SPD1000X Over Current Protection (OCP) function added in Firmware Revision 2.1.1.9

March 16, 2022

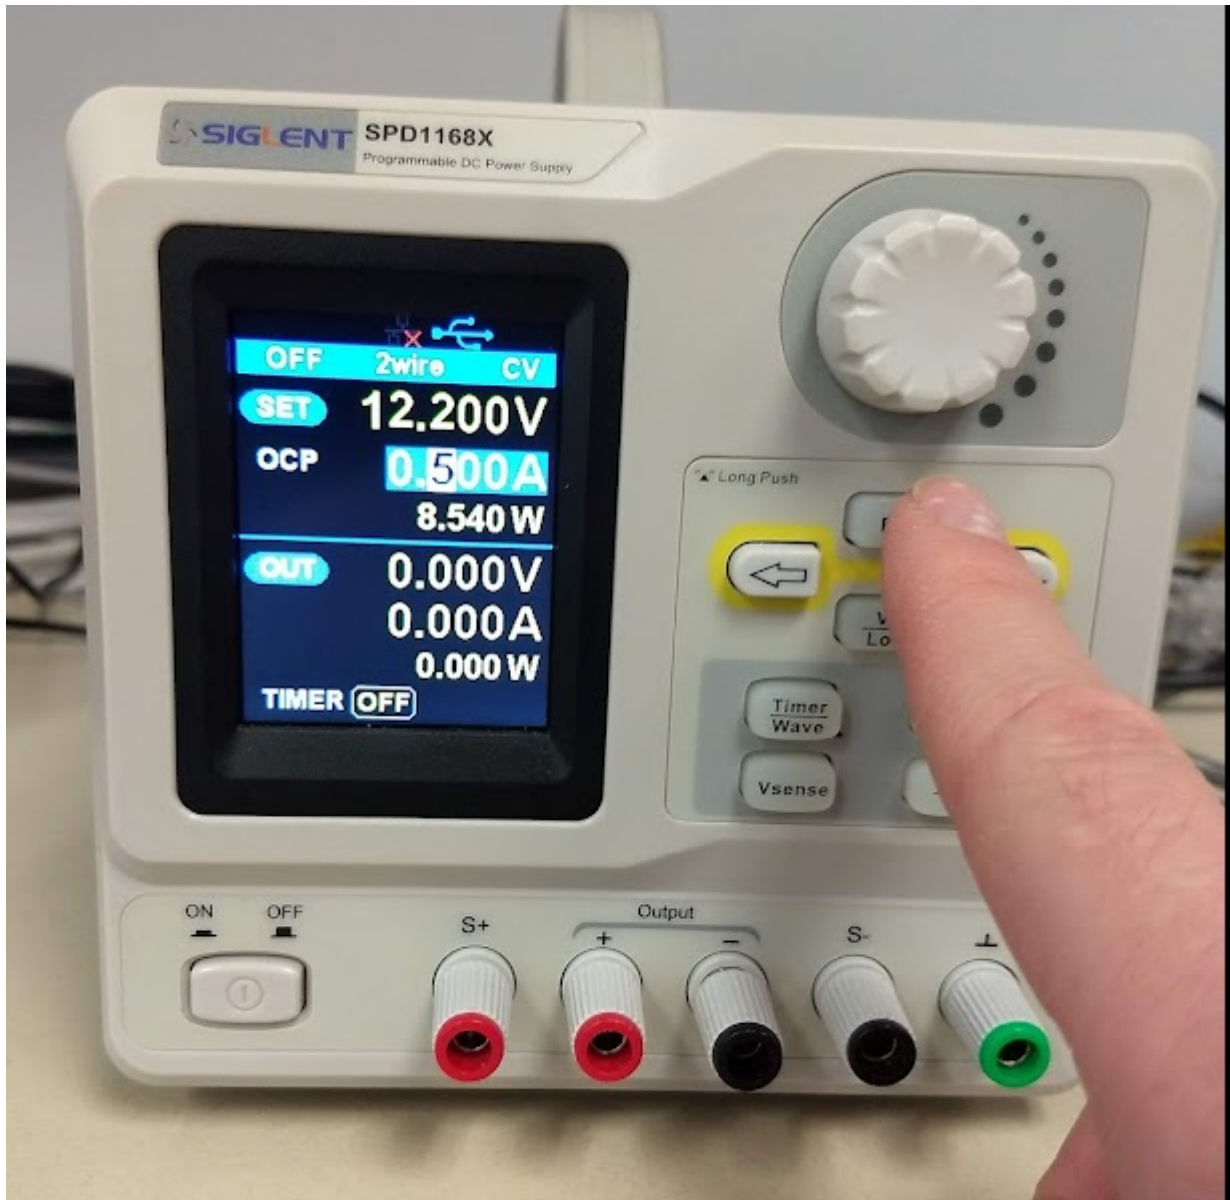
1. Update the [firmware](#)
2. Set the OCP value by pressing and holding the FINE button on the front panel. After a few seconds, the OCP label will appear:

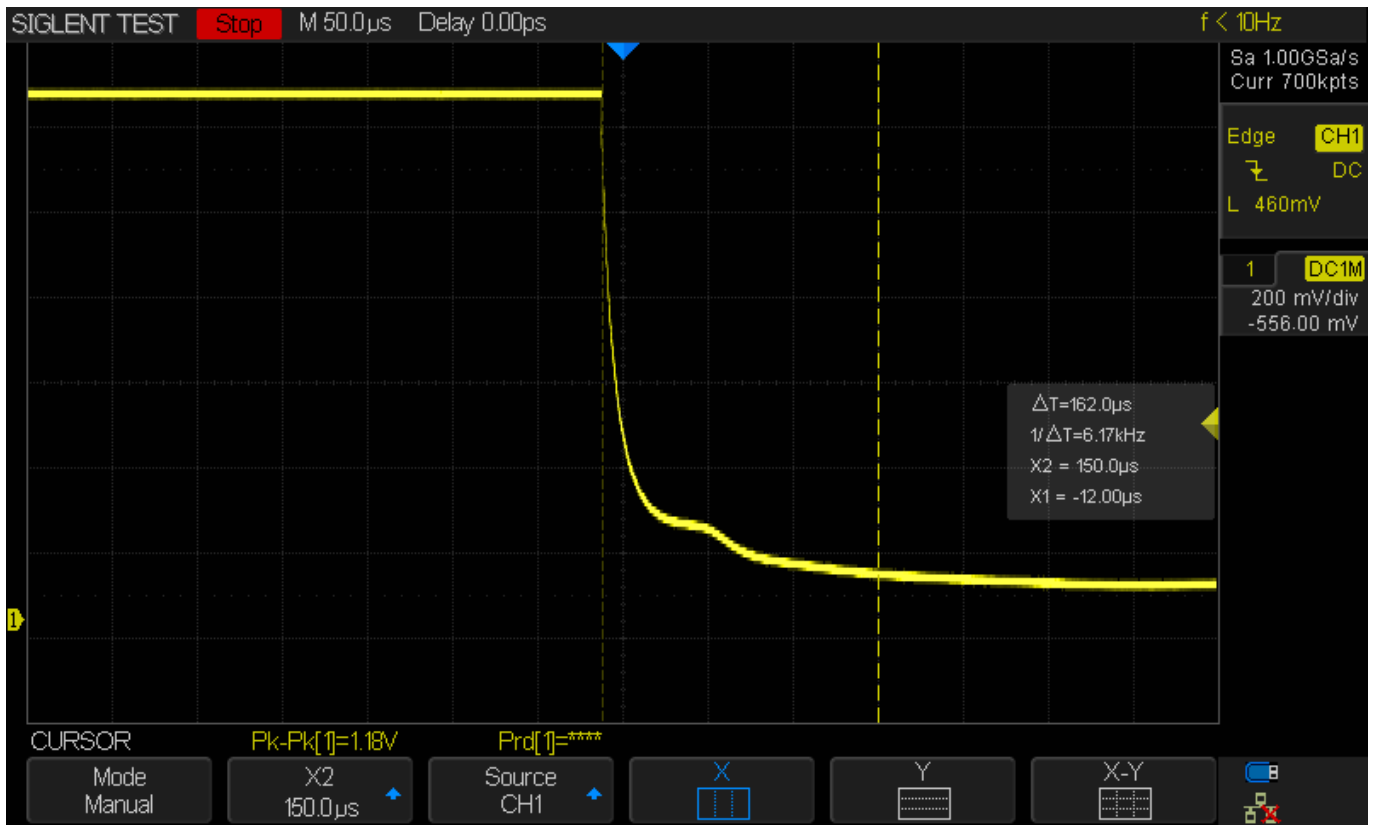
3. Set the OCP current value using the knob and right/left arrows to adjust.
4. Long press the FINE button to remove the OCP menu selection.
5. If the output exceeds the setpoint, the instrument will immediately disable the output and briefly show an error:

Here is an oscilloscope trace showing a shorted output causing an overcurrent situation (OCP triggered):
